SUBJECT: CLARIFICATION OF TECHNICAL SPECIFICATIONS (TAC NO. 61000)

RE: LIMERICK GENERATING STATION, UNIT 1

AMENDMENT TO FACILITY OPERATING LICENSE

Amendment No. 29  
License No. NPF-39

FIGURE 3.4.6.1-1

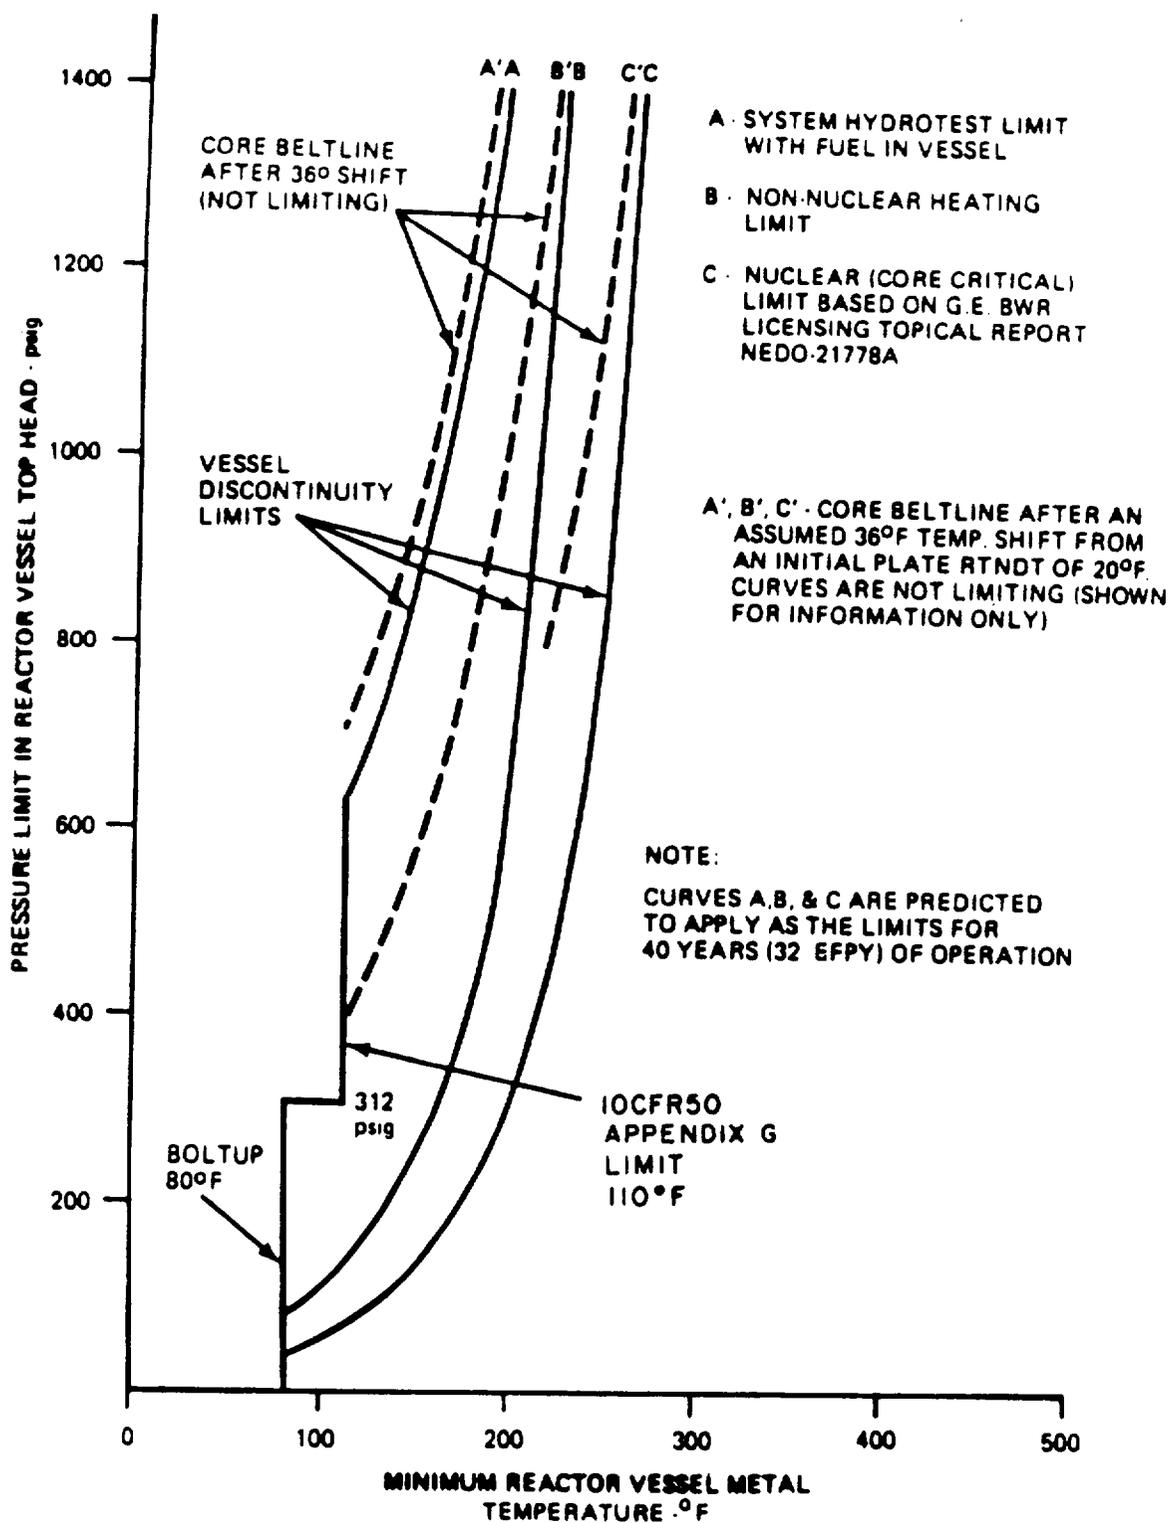
The requirements on removal of flux wire specimens on page 3/4 4-19 refers to figures B 3/4 4.6-1 and B 3/4 4.6-2. The latter was not included in the TSs issued by the Commission (NUREG-1149). The reference to the second figure is an error which the licensee proposes to correct by the requested changes. The proposed change is acceptable since it corrects an error in the Bases (which are not part of the TSs).
